Sub: Amendment-1 to technical circular No. RDSO/2011/EL/TC/110(Rev.0) dated 24-06-11

**Amendment no.1 to Technical Circular No. RDSO/2011/EL/TC/110(Rev.0)
dated 24-06-11**

Modified Circuit Diagram

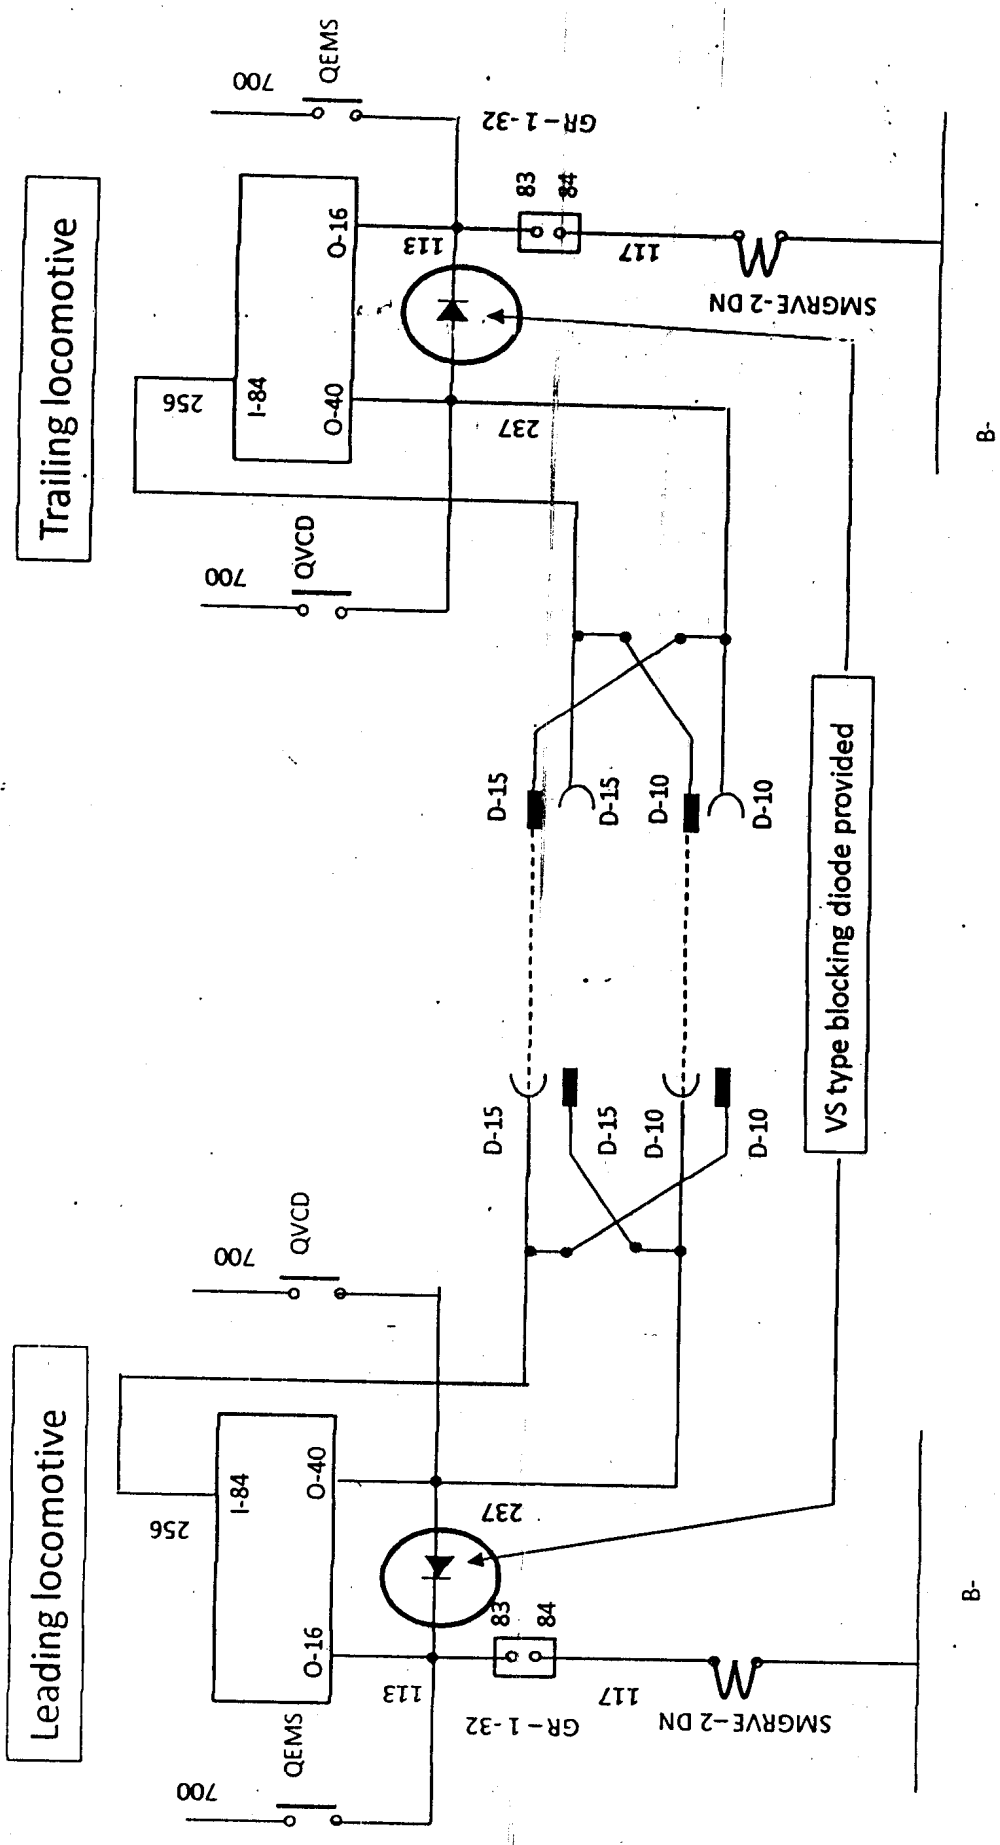
South Eastern Railway vide their letter under reference has informed that in MPCS fitted locomotives, in case of tripping in leading loco, notch gets regressed in trailing loco and vice versa due to I-84 of trailing loco gets high through MU jumper and suggested provisioning of blocking diodes between wire no. 113 and 237 i.e. output of O-16 and Output of O-40 so as to avoid above problem. The issue has been examined and accordingly amendment-1 to Technical Circular is enclosed for your information and necessary action.

S. No.	Existing arrangement	Amended as
1.	Annexure-VI Instructions for fitting Vigilance Control Device in locomotives fitted with MPCS	Para E to be added in Annexure-VI as follows: One no. blocking diode VS type shall be provided between wire No. 113 (output of O-16) and wire no. 237 (Output of O-40) to prevent shorting of wire no. 113 and 237 Alternatively supply from output of two separate N/O contacts may be extended to wire no. 113 and wire no.237. Please refer Schematic-3 (attached) for providing blocking diode.
